Huggens College, College Road, Northfleet - GB/20240402

RE: KENT HIGHWAYS CONSULTEE COMMENTS

ADDITIONAL INFORMATION REQUEST

Application - GB/20240402

Scale 1:500	@ A3	SLR Project No.	
Designed AA	Drawn AA	Checked TF	Authorised AT
Date 30.07.24	Date 30.07.24	Date 30.07.24	Date 30.07.24
Drawing Number 418.063079.00001-AT02			Rev. -

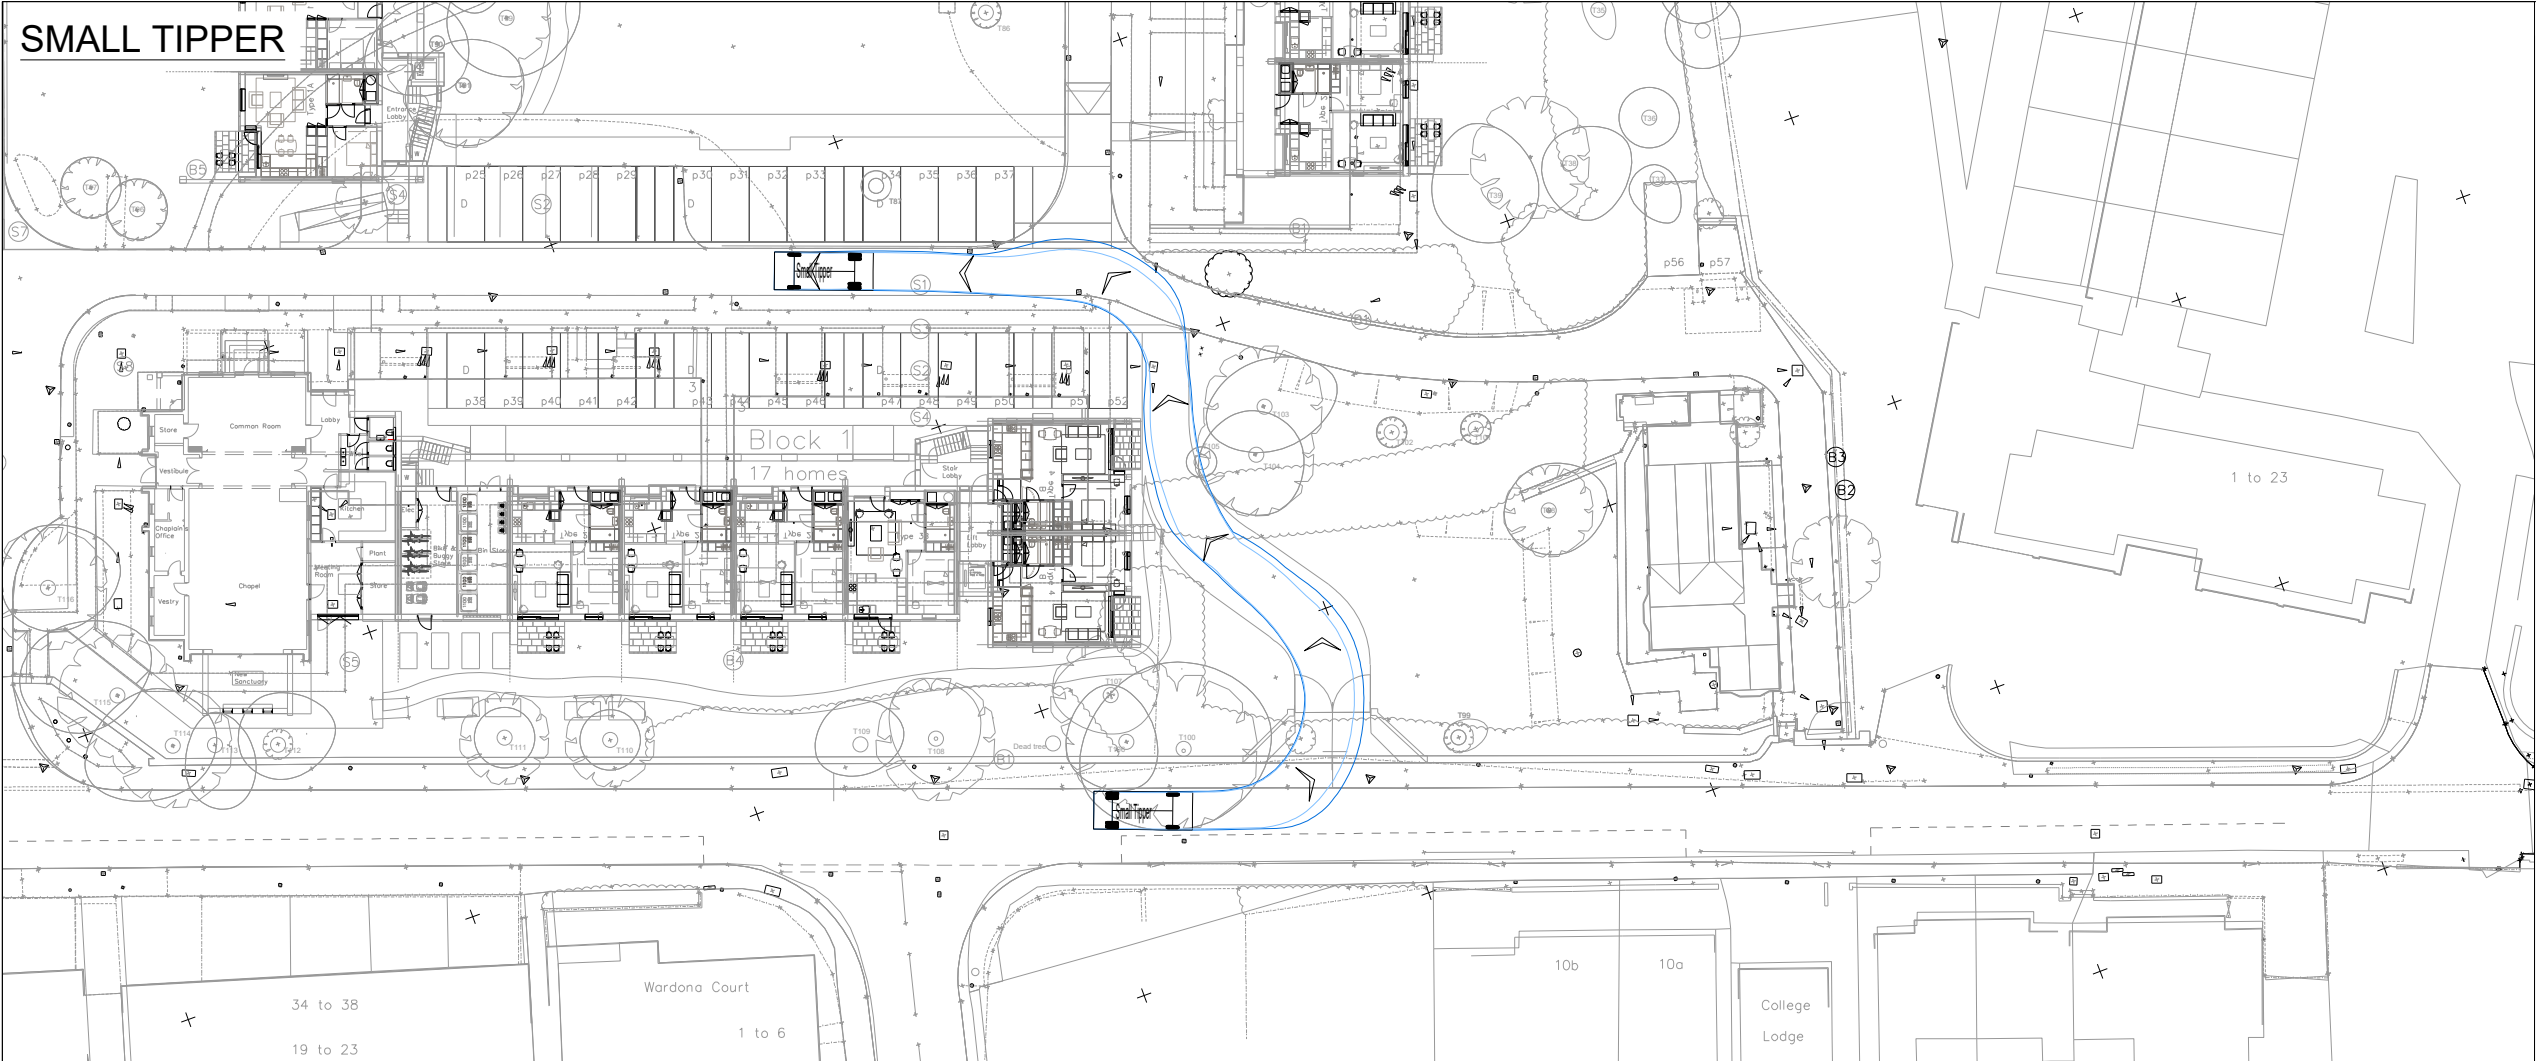
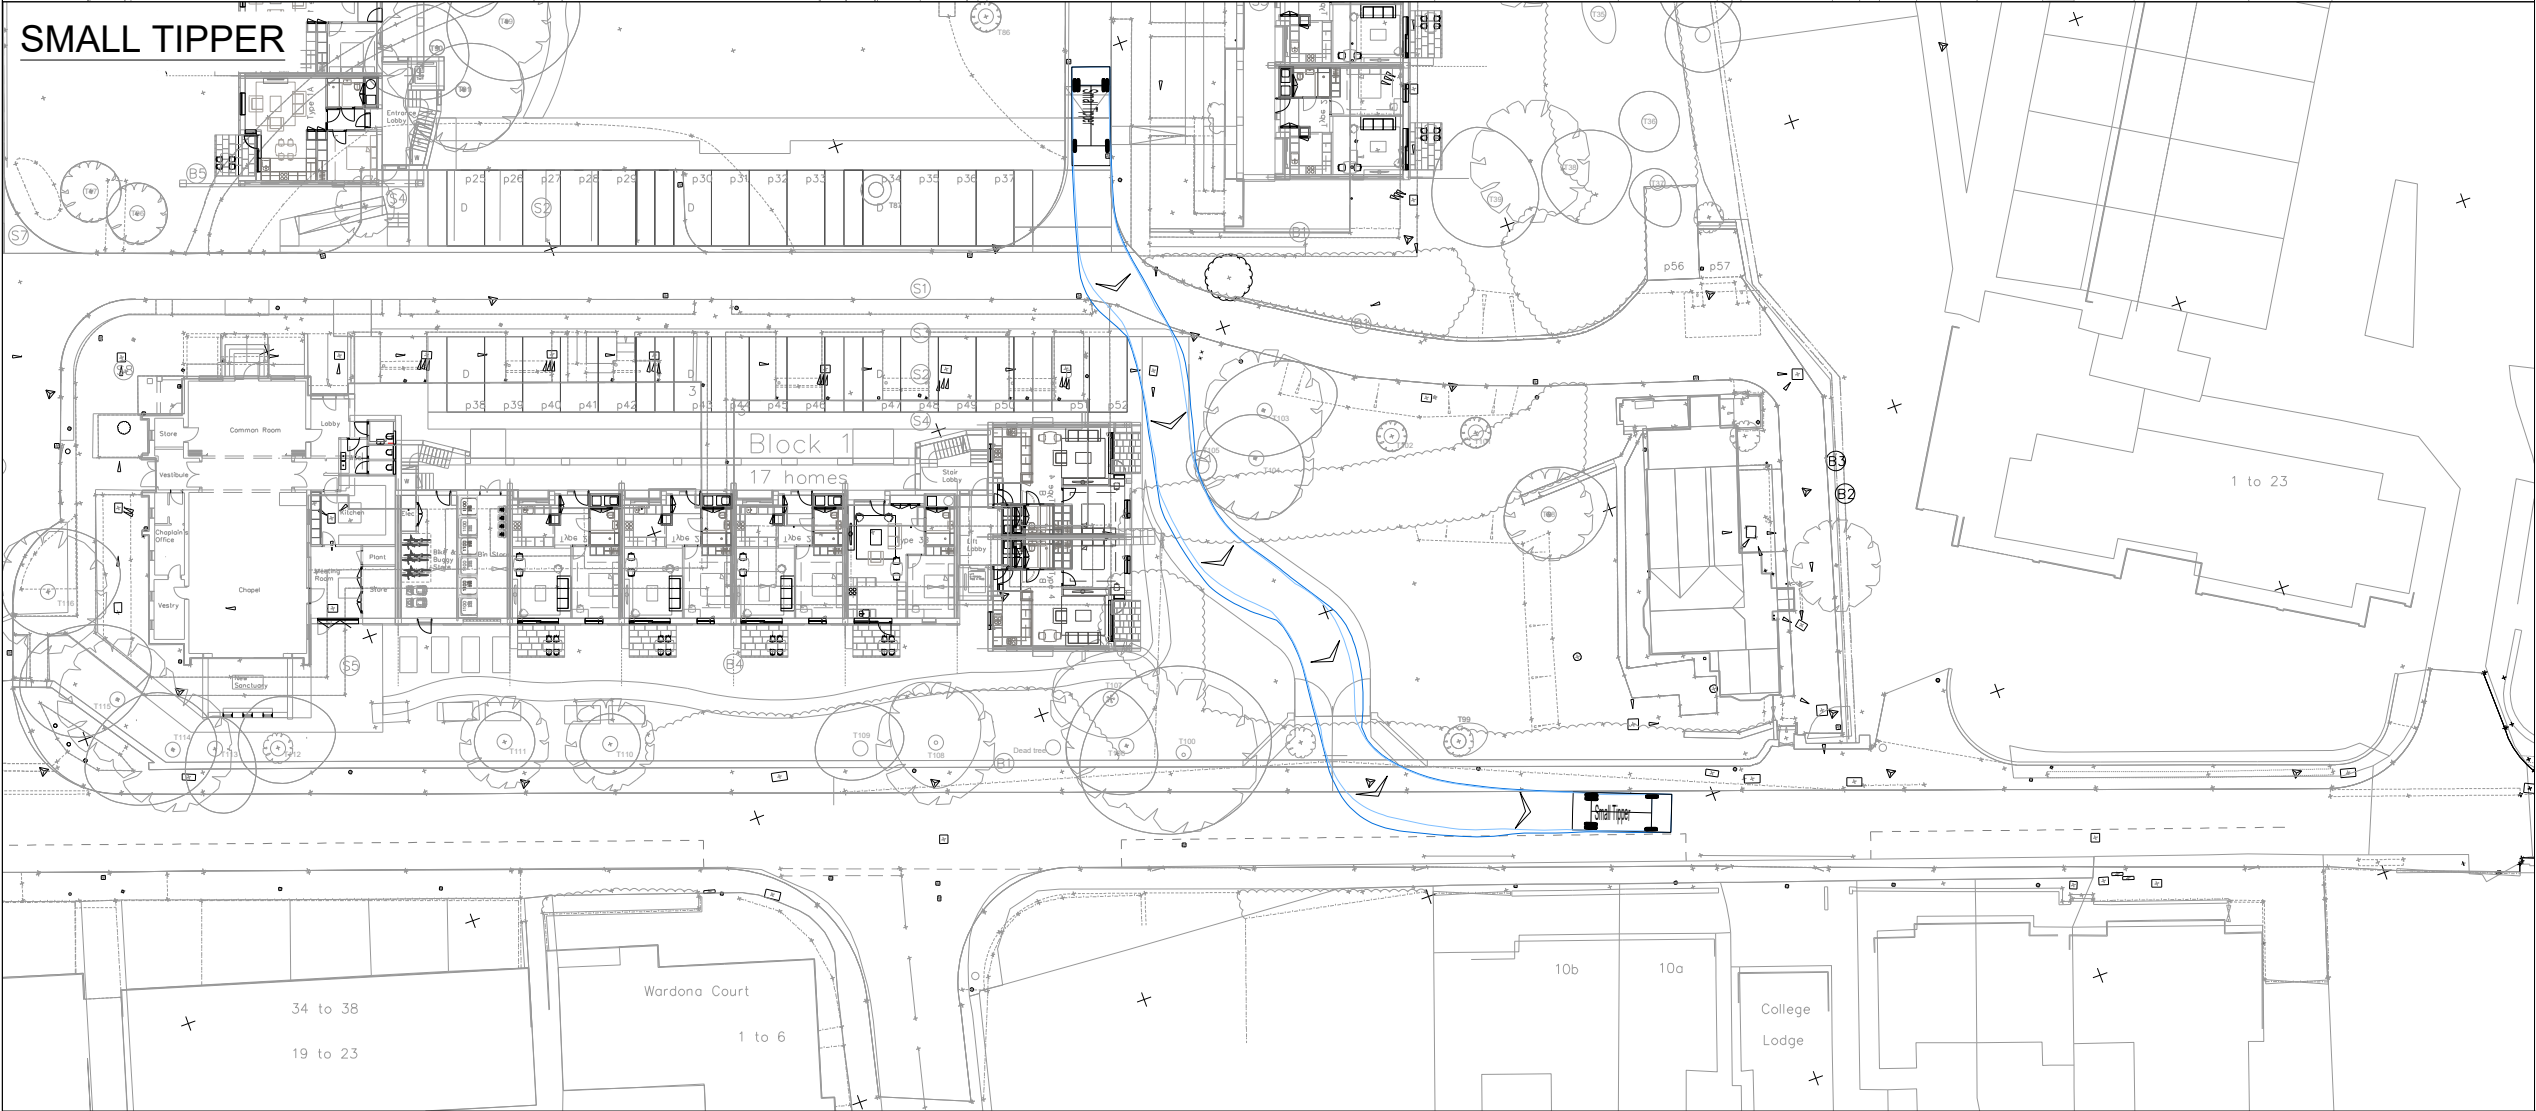
Tracking of a refuse vehicle has been provided and is acceptable. However, no tracking has been provided for the temporary access. Tracking of a fire appliance vehicle is required. Alternatively, if this access is to be used for construction, tracking for the largest construction vehicle likely to access the site, could also be shown (if not, this will be requested for the Construction Management Plan).

A swept-path analysis is attached at **Appendix E** which shows a fire tender can access and egress in a forward gear. Additionally, the swept-path analysis includes the turning requirements for a small tipper and skip lorry demonstrating that the secondary access could also be used for construction vehicles for development phasing purposes.

Drawing No.	Rev
1000008900-4-S11-0100-0001	4

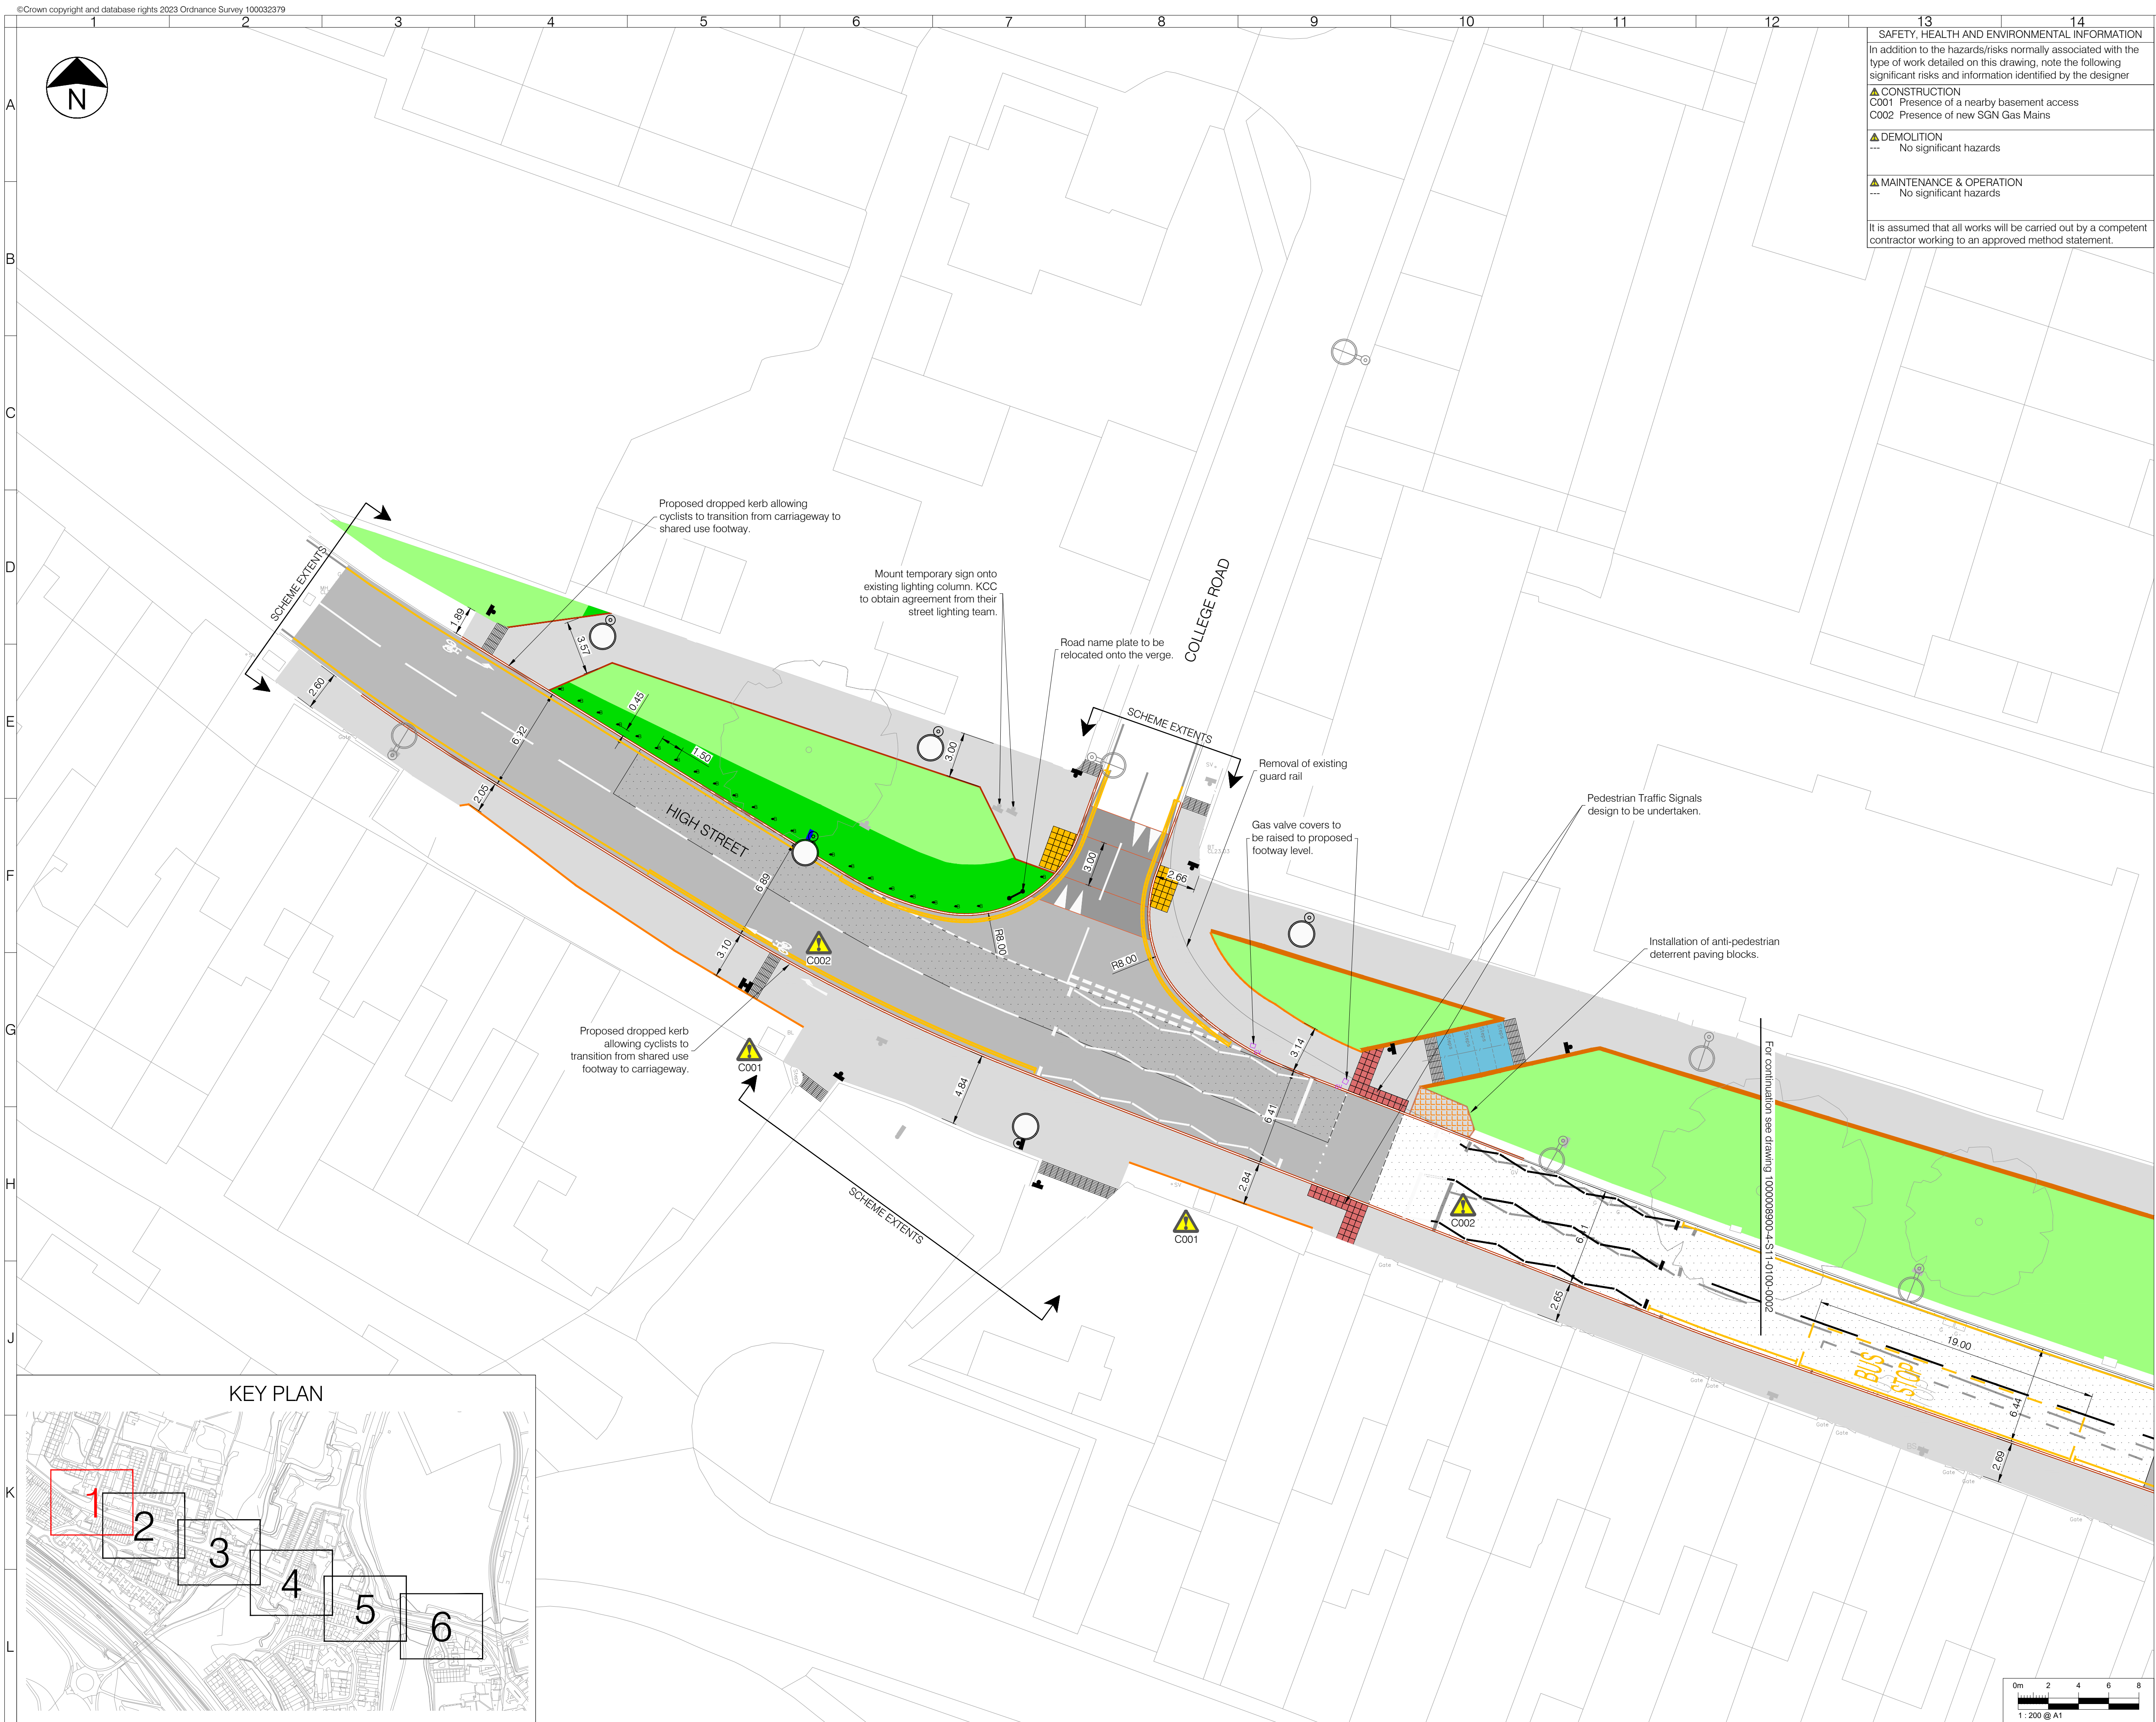
There is a KCC Green Corridors scheme to enhance cycling facilities along the High Street between College Road and Vicarage Drive ("site 11"), which will be implemented in late 2024 / 2025. The scheme proposes changes to the area directly south of the site, where the proposed gate is located, which will helpfully enhance cycling facilities for the users of the proposed development.

It is noted that the gated pedestrian access will emerge onto Stonebridge Road adjacent to KCC's Greenway Corridor Site 11 (Northfleet High Street). SLR has obtained the latest proposals for the Greenway Corridor scheme, attached at **Appendix F**. The proposed gated access is clearly compatible with the Greenway Corridor proposals.
